Lower Chester Community Club

Accessibility Review

Transition Plan - (location/priority)

Lower Chester Park Community Club

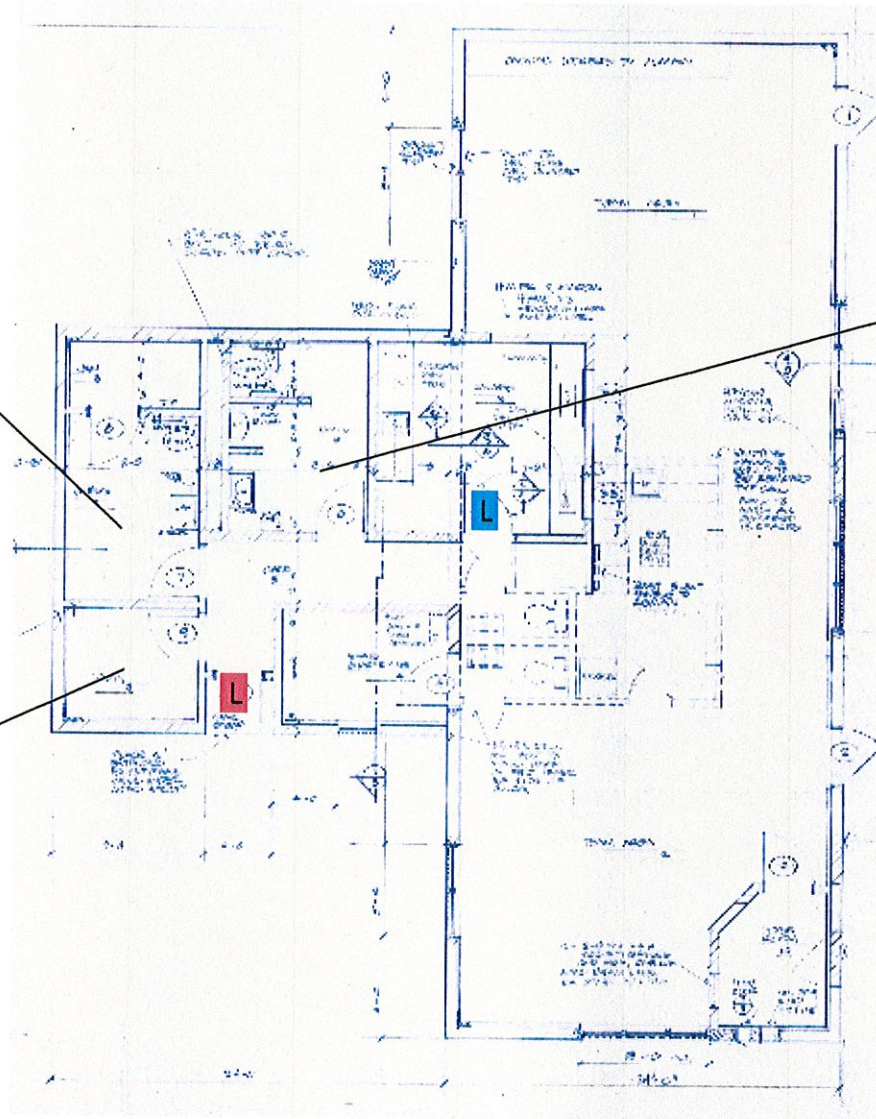
Add raised and braille sign
 Replace faucet
 Replace grab bars
 Add full height mirror
 Remove door closer

Add raised and braille sign
 Replace faucet
 Lower towel dispenser
 Relocate toilet paper dispenser
 Replace grab bars

Add raised and braille sign

L Install door lever hardware
